Date: 25 June 2022 at 14:02:54 BST
To: Selina Donophy
Subject: APP/22/00475 and APP/22/00476

There are many concerns in reinstating the derelict chimney as a conduit for a log burner flue as detailed in the above applications.

Image 1

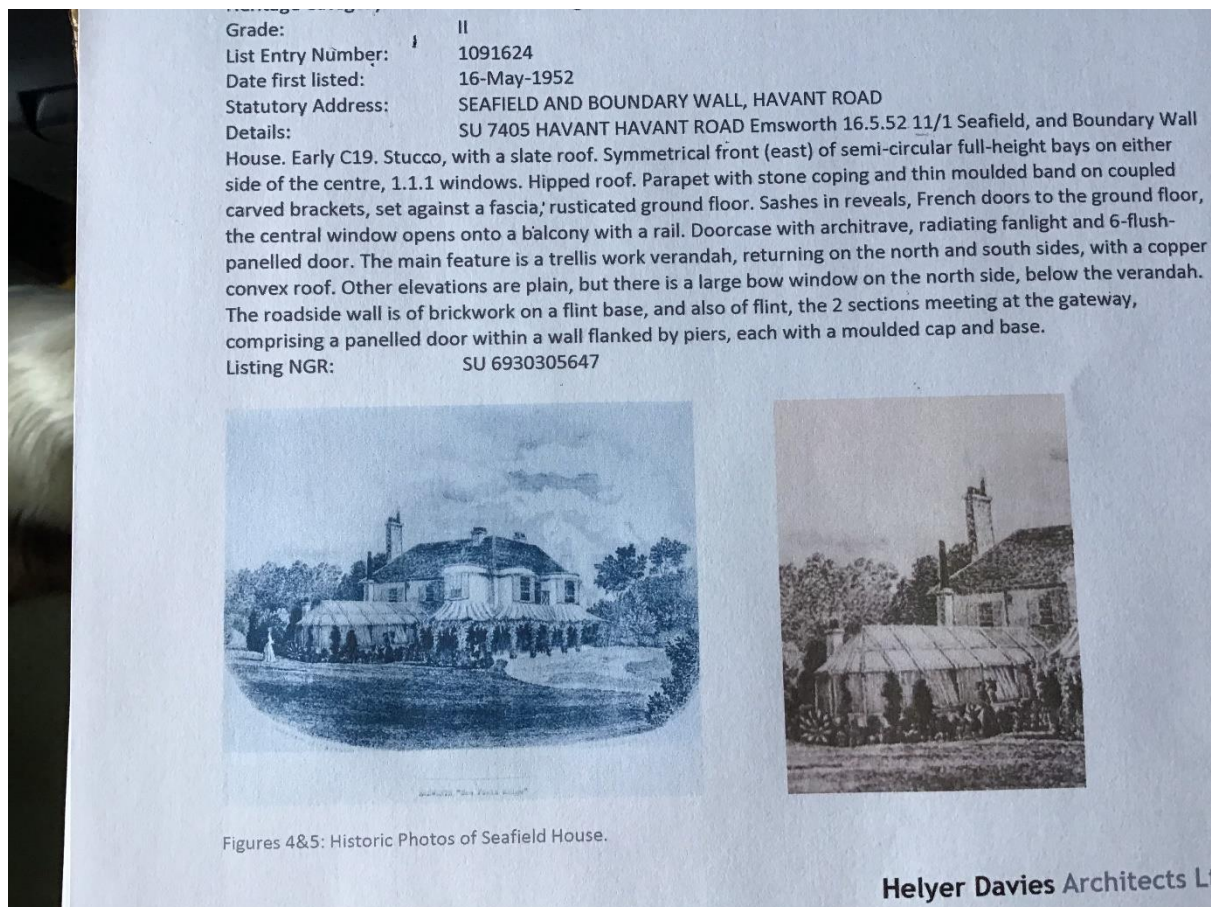
The sketches Fig4&5 which are to inform the height, materials etc are in fact fiction. (Image 1)The sketches are titled Sea Field Lodge and they are identical. Little Seafield which is Grade11 listed is only half drawn in the sketch. The additional servants quarters were added later. The chimney is not brick but C19 stucco shown adjacent to the stainless steel flue outlet and over 200 years of weathering has this grey appearance from lichen, black cover added by previous owner to stop rain water going into greenhouse. (Image 2)

The drawings Fig4&5 predate the listing and if the derelict small chimney is built up to conform to building regulations then the outlook from Little Seafield which had then not been altered to provide servants quarters will be hugely impacted. So building a chimney on the rear west side of Seafield House would result in the positioning of a brick column (50cmx50cmx600cm) in the front elevation of the listed building Little Seafield. The agent Helyer Davies does not mention that Little Seafield and Seafield House are both listed semi detached and that Seafield was converted in 1975 to these two dwellings by a London Architect. The London architect lived in Little Seafield after it’s conversion. The two properties are connected like interlocking parts of a jig saw so although the chimney is on a boundary it appears in the mid view of a Regency window of Little Seafield. Deprivation of light would also be a problem in a South facing terraced garden.

So the drawings (image 1) are irrelevant, unreliable and cannot be used to reinstate a chimney for a flue outlet. They predate the listed Seafield and have been named Sea Field Lodge by the artist. The conservatory as it is now bears little resemblance to the sketch and the listed Little Seafield is not shown in it’s entirety. Little Seafield is the older part of Seafield and evidence of the Smithy, farm, Clome oven, flagstone floors, outside cellars are still present on the Little Seafield side.
